ADDENDUM
NO. 1

July 16, 2020

Additions & Renovations to Lawrence North High School
7802 Hague Road
Indianapolis, IN 46256

PREPARED BY SCHMIDT ASSOCIATES FOR:
LAWRENCE NORTH HIGH SCHOOL RENOVATION
LAWRENCE TOWNSHIP, M.S.D. OF

P. **Drawing Number MDP1J1**

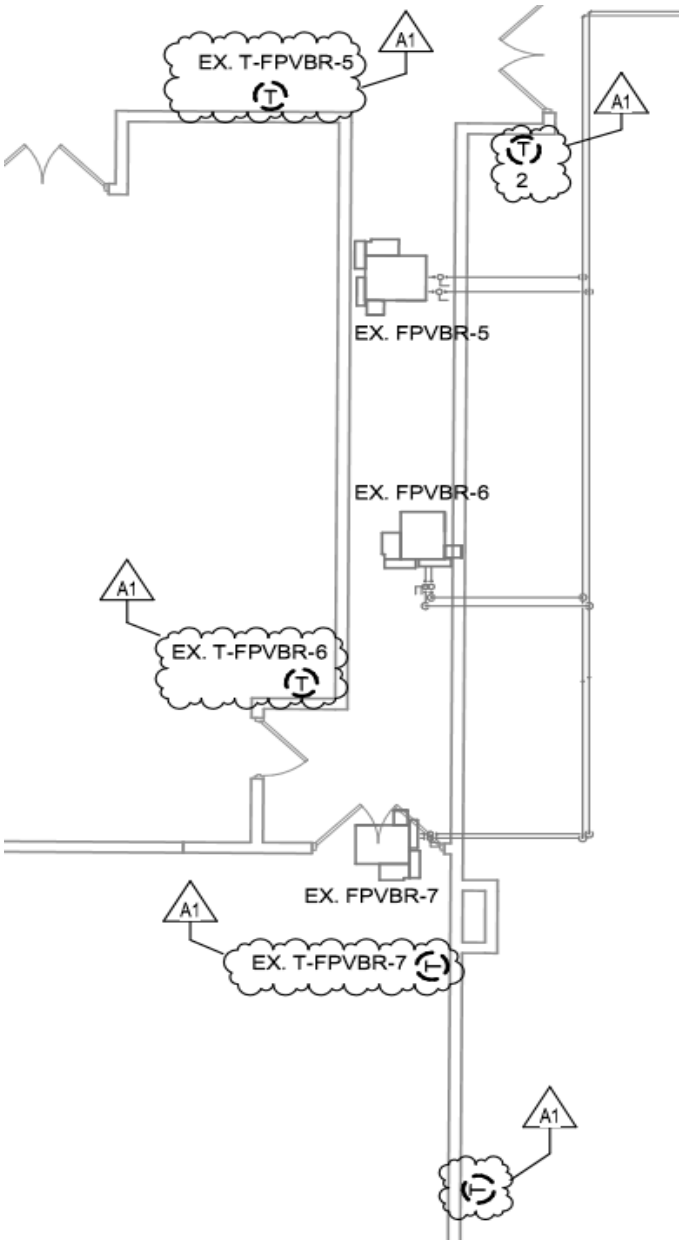
1. MODIFY drawing to remove existing thermostat as follows:

T. **Drawing Number MH1E1**

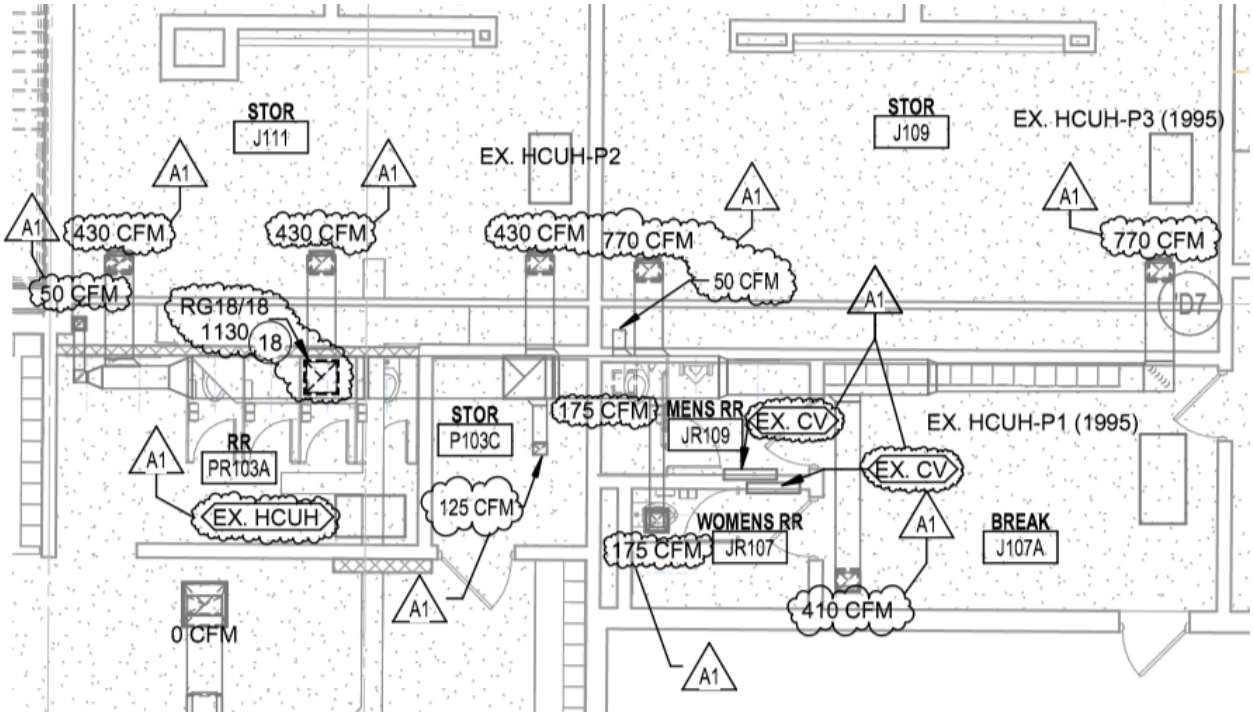
1. MODIFY drawing to add the following CFM's as follows:

V. **Drawing Number MH1E1**

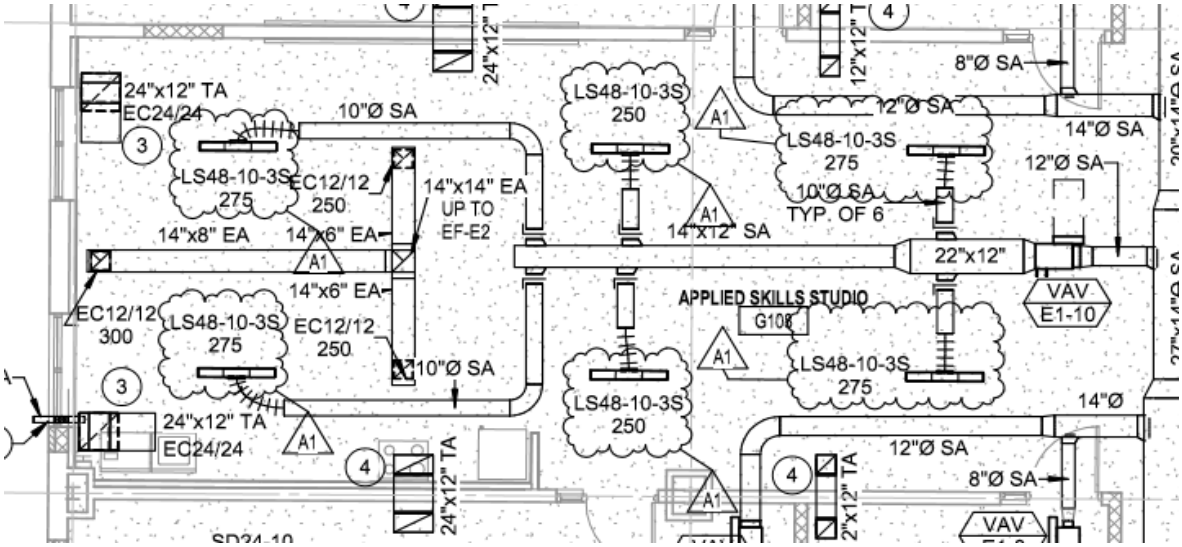
1. MODIFY drawing to add the following diffusers and duct modifications as follows:

AA. **Drawing Number MH1F1**

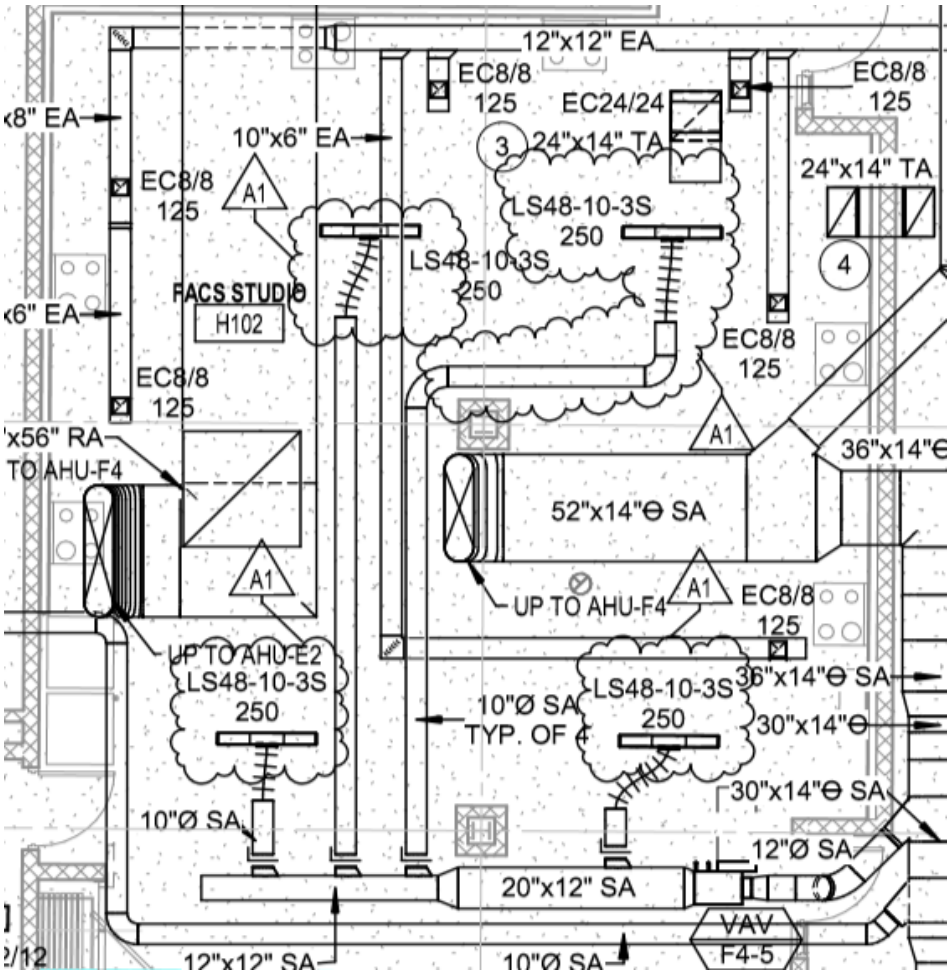
1. MODIFY drawing to add the following CFM's and duct modifications as follows:

BB. **Drawing Number MH1F1**

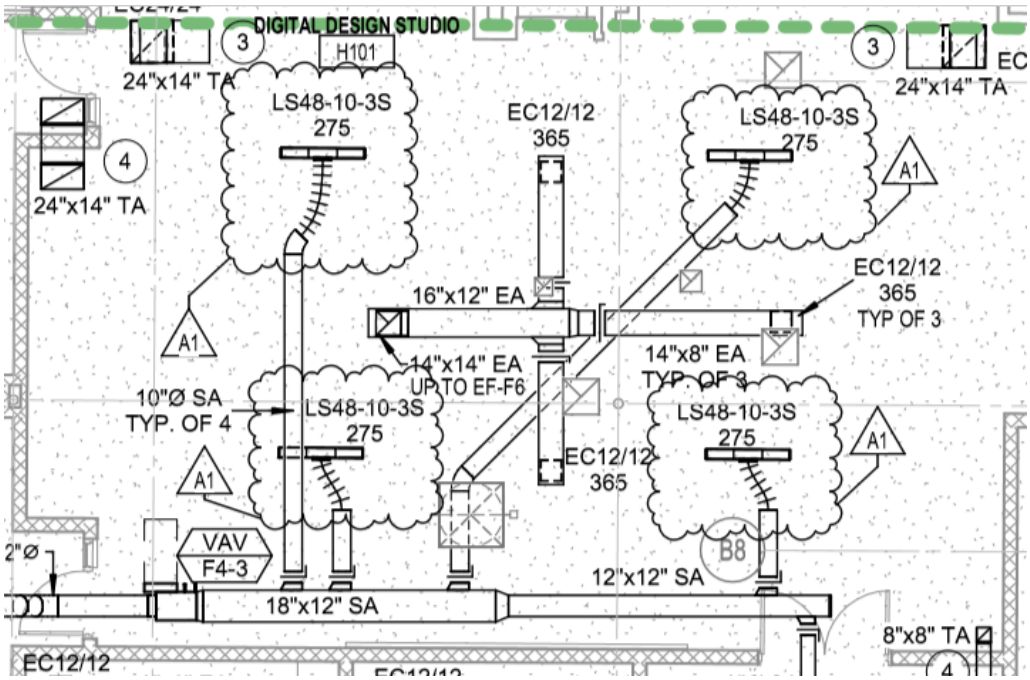
1. MODIFY drawing to add the following CFM's and duct modifications as follows:

CC. **Drawing Number MH1F1**

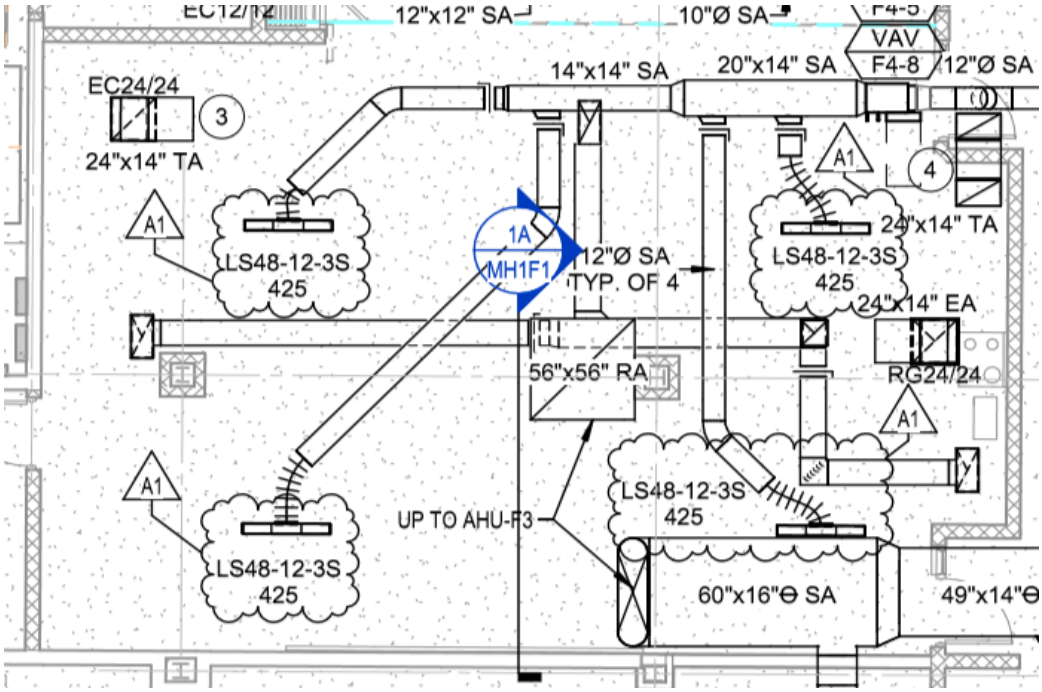
1. MODIFY drawing to add the following CFM's and duct modifications as follows:

DD. **Drawing Number MH1F1**

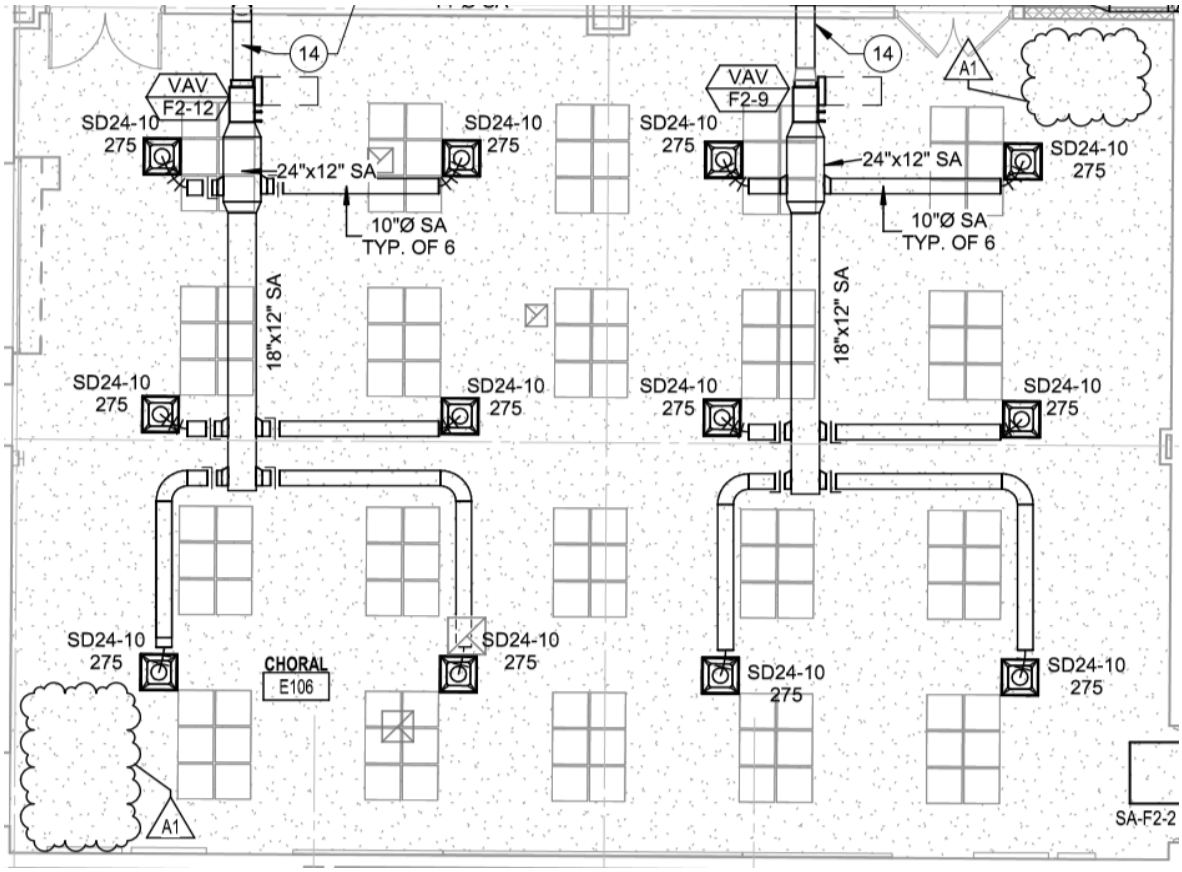
1. MODIFY drawing to delete return air grilles as follows:

GG. **Drawing Number MH1H1**

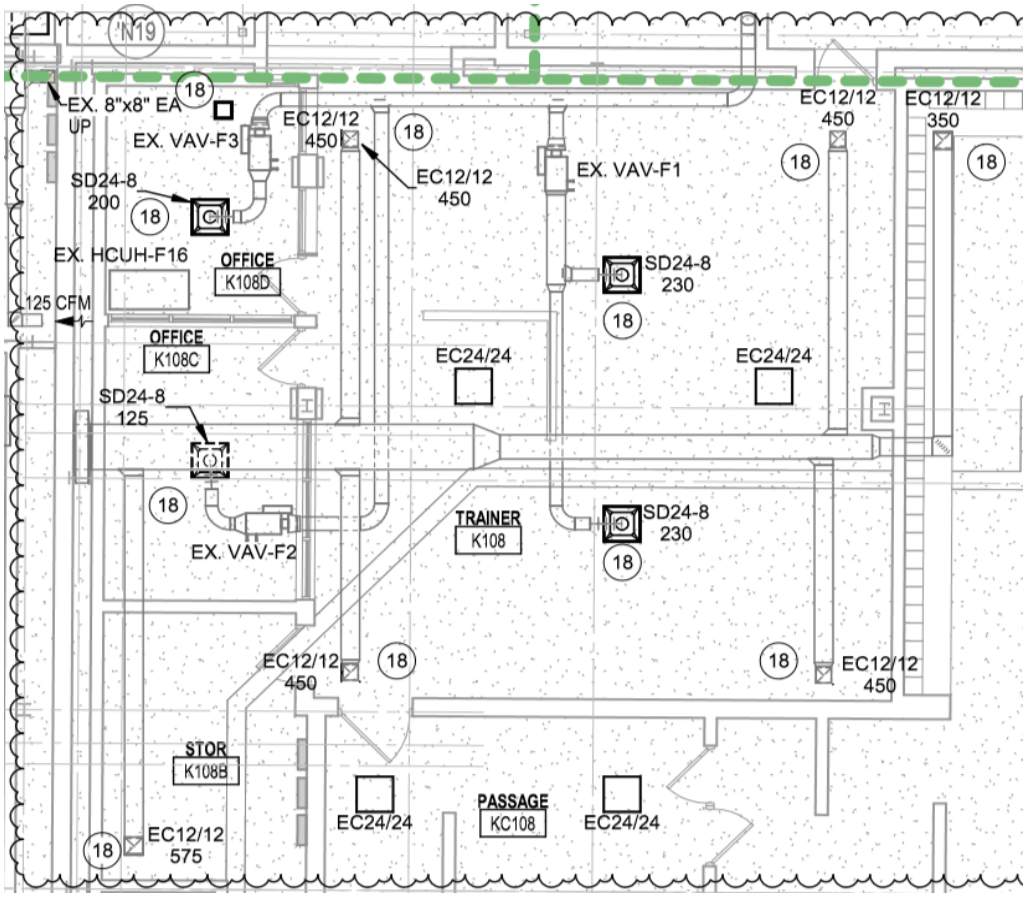
1. MODIFY drawing to show existing duct to be reconnected to new diffusers as follows:

HH. **Drawing Number MH1H1**

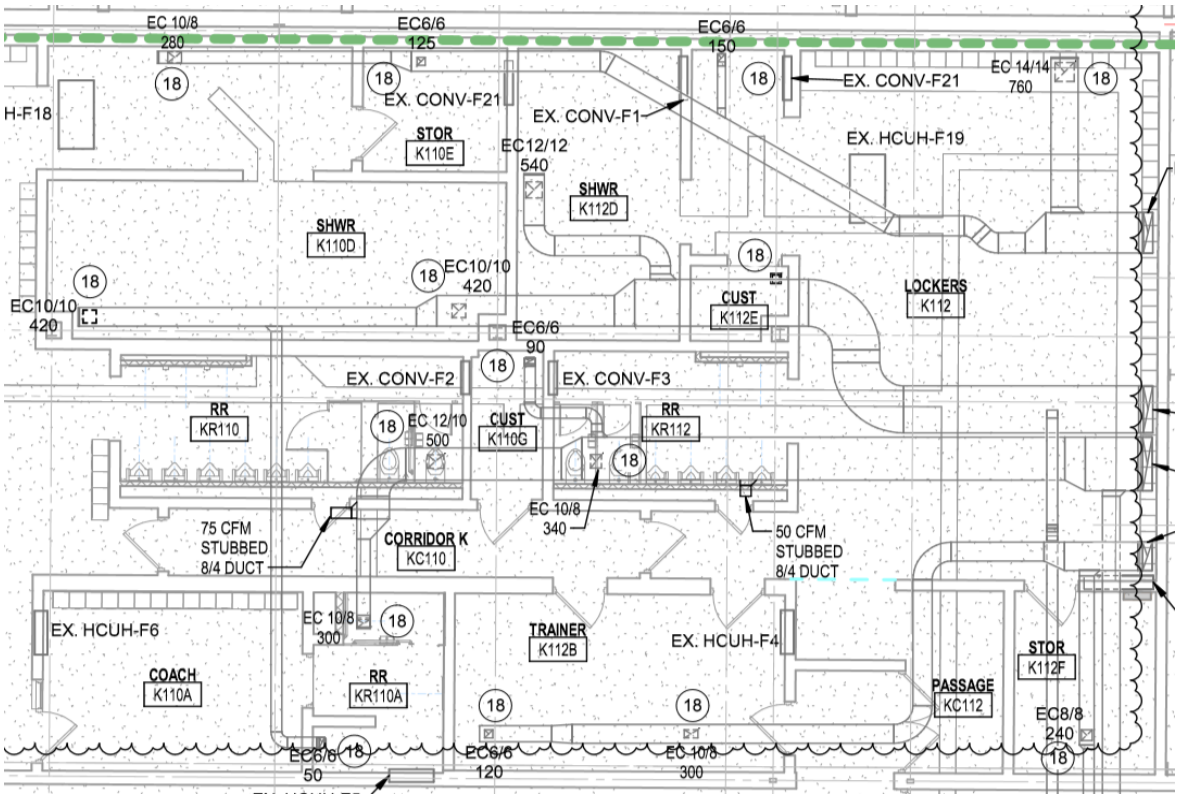
1. MODIFY drawing to show existing duct to be reconnected to new diffusers as follows:

II. **Drawing Number MH1H1**

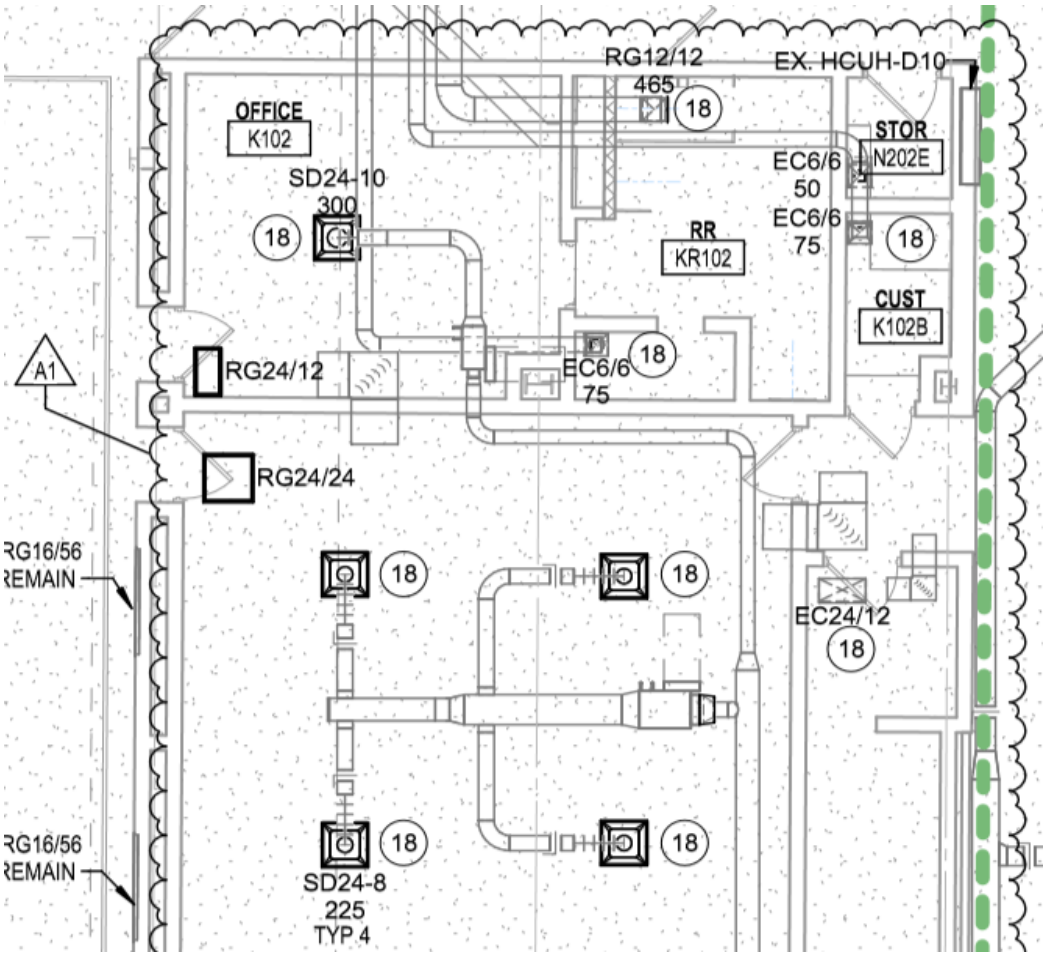
1. MODIFY drawing to show existing duct to be reconnected to new diffusers & new return air grilles as follows:

JJ. **Drawing Number MH1H1**

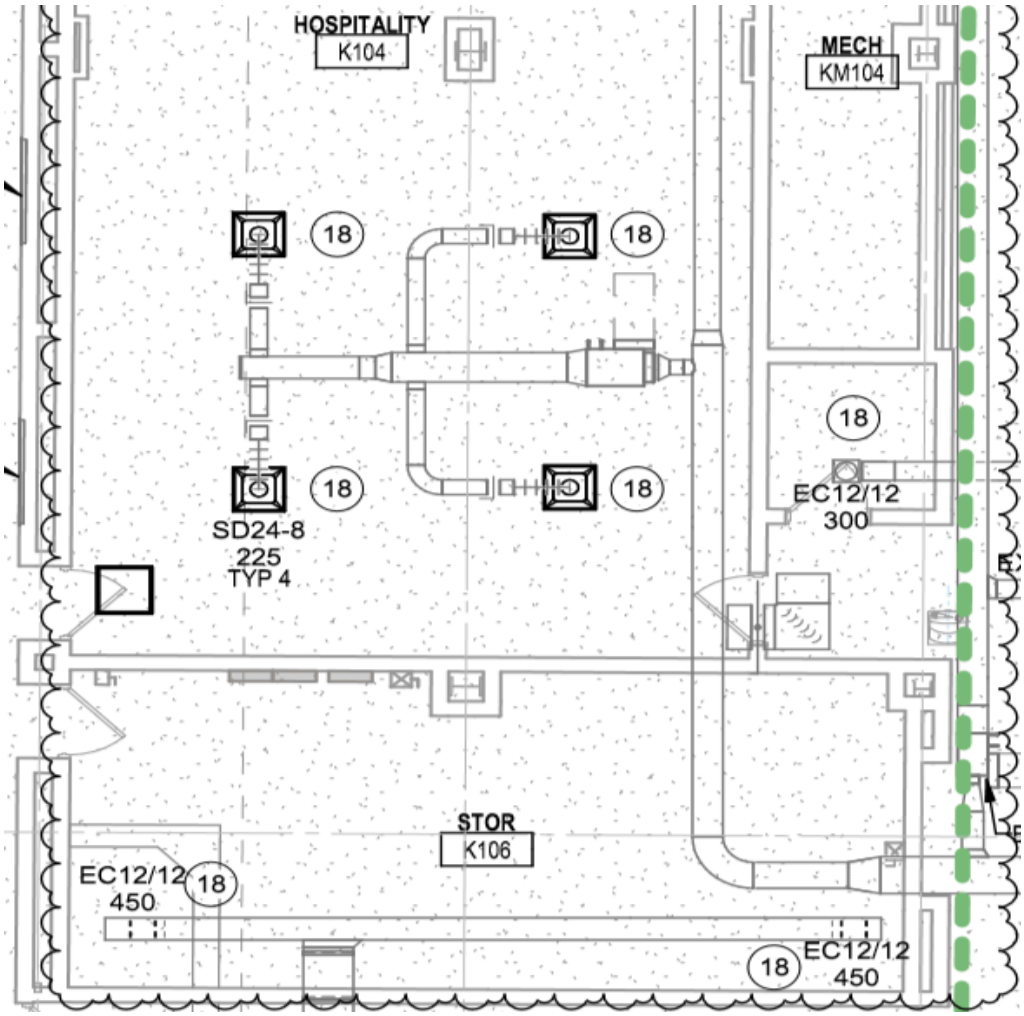
1. MODIFY drawing to show existing duct to be reconnected to new diffusers & new return air grilles as follows:

KK. **Drawing Number MH1H1**

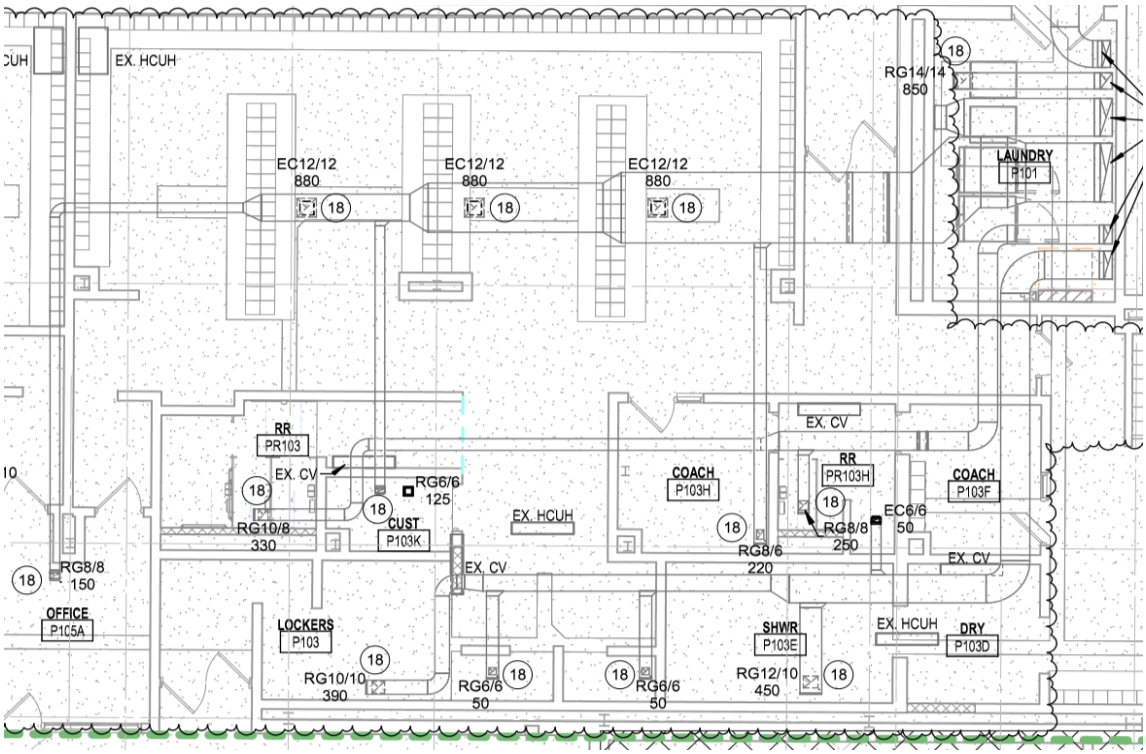
1. MODIFY drawing to show existing ductwork to be reconnected to new diffusers & grilles as follows:
